UNITED STATES PATENT AND TRADEMARK OFFICE

APPLICATION NO.	FILING DATE	FIRST NAMED INVENTOR	ATTORNEY DOCKET NO.	CONFIRMATION NO.
10/828,423	04/19/2004	Kyeong Hwan Doo	5895P057	5360
8791 7590 04/11/2007 BLAKELY SOKOLOFF TAYLOR & ZAFMAN 12400 WILSHIRE BOULEVARD SEVENTH FLOOR LOS ANGELES, CA 90025-1030			EXAMINER ROJAS, OMAR R	
			ART UNIT 2874	PAPER NUMBER
SHORTENED STATUTORY PERIOD OF RESPONSE		MAIL DATE	DELIVERY MODE	
3 MONTHS		04/11/2007	PAPER

Office Action Summary

DETAILED ACTION

FIG. 3

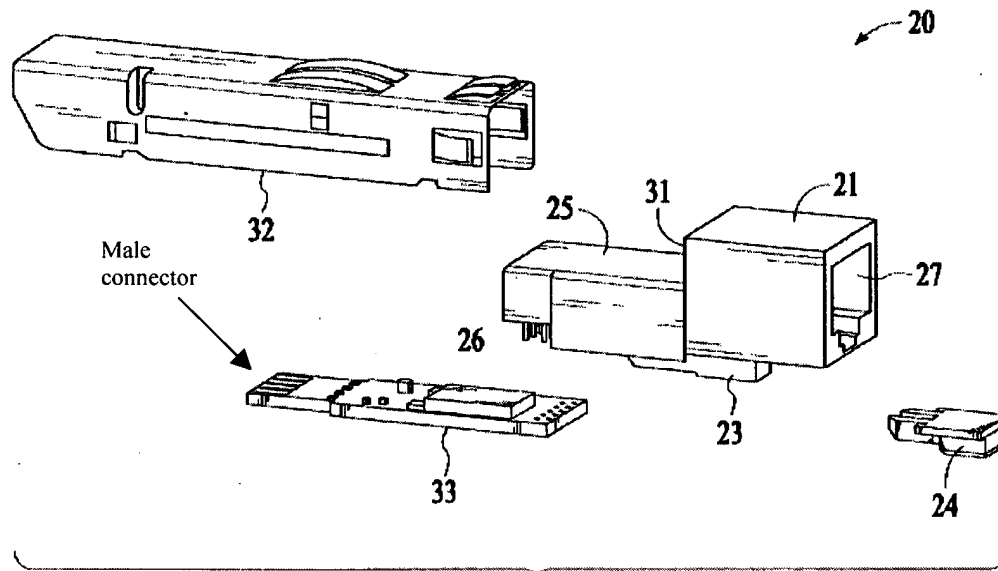
a board 33 having the same dimensions as those of the optical module;
a male connector (see the modified Figure 3 of Engle below), having the same dimensions as those of the optical module, formed at a side surface of one end of the board 33 and connected to the female connector 12 for the optical module mounted on a host board 11;
and

wherein the board 33 and the male connector have the same dimensions as the SFP type optical module (column 2, lines 32-35). For applicant's convenience, a modified version of Figure 3 of Engel is reproduced below that includes a label for the male connector.

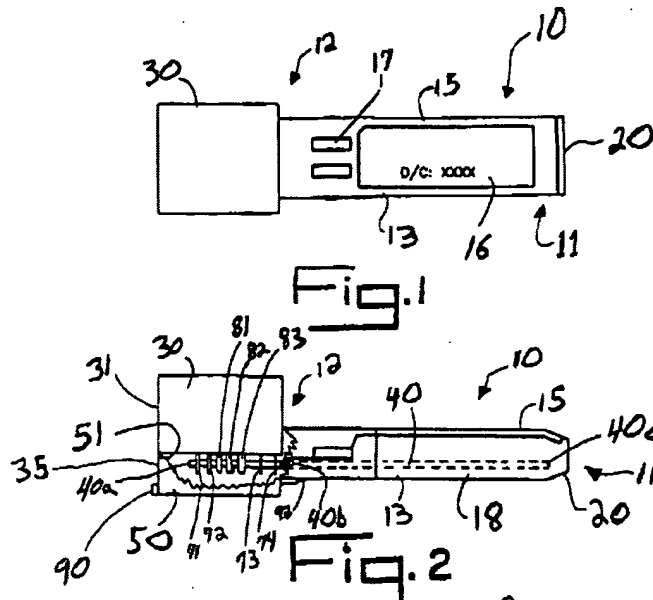
In re claims 1-3, Daly discloses, in Figures 1-5, an optical module interfacing device 10, connected to a host device for an SFP type module for providing data transmission/reception functions through an UTP cable, comprising:

a board 40 having the same dimensions as those of the optical module;

a male connector 20, having the same dimensions as those of the optical module, formed at a side surface of one end of the board 40 and connected to the host device; and

an RJ-45 female connector 30 provided with a plurality of pins 71-74 formed on an upper surface of the board, respectively corresponding to pins of the male connector 20, according to standards;

wherein the board 40 and the male connector have the same dimensions as the SFP type optical module (col. 3, line 64 to col. 4, line 2). Figures 1 and 2 of Daly are reproduced below.

FIG. 1

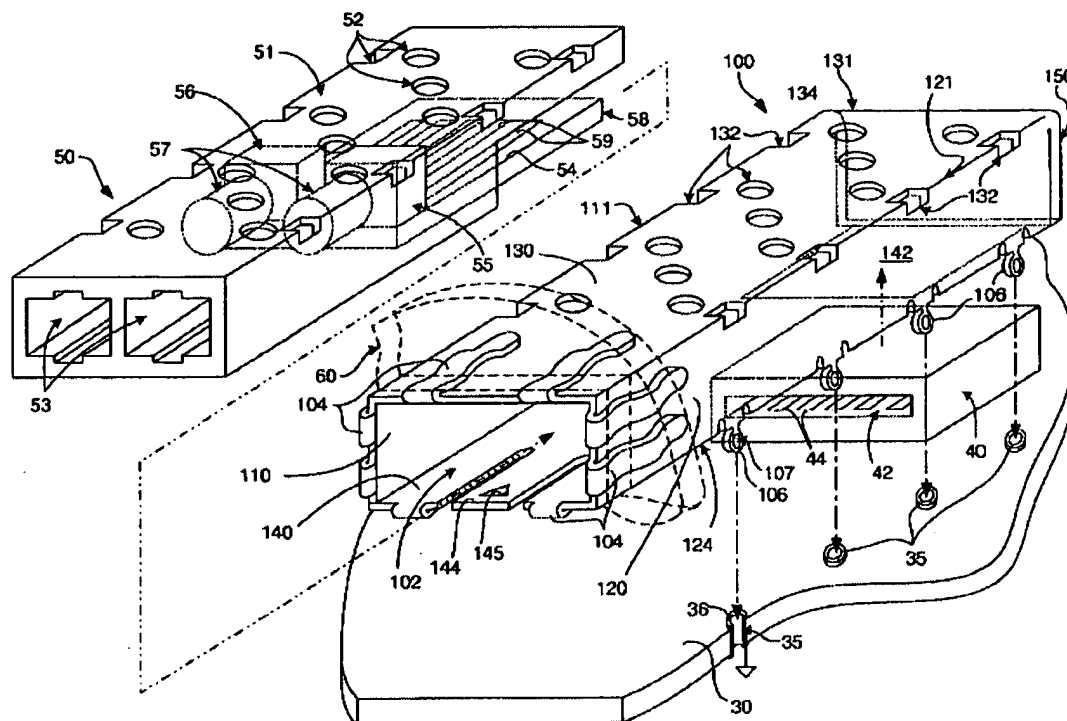
In re claims 5-7, Ahrens discloses an ethernet system (Figure 1) for supporting data communication through optical cables comprising:

an interfacing unit 40/42/44, mounted on the host board 30 and including a female connector 40 having the same dimensions as those of the optical module, for connecting the optical module 50/100 to optical data communication supporting ports of the physical layer when the optical module is inserted into the female connector

wherein the optical module 50/100 is detachably mounted on the interfacing unit 40/42/44. Figure 1 of Ahrens is reproduced below.

Thus, Ahrens only differs from claims 5-7 in that Ahrens does not teach an optical module interfacing means provided at an end of a UTP cable having the limitations specified by claims 5-7.
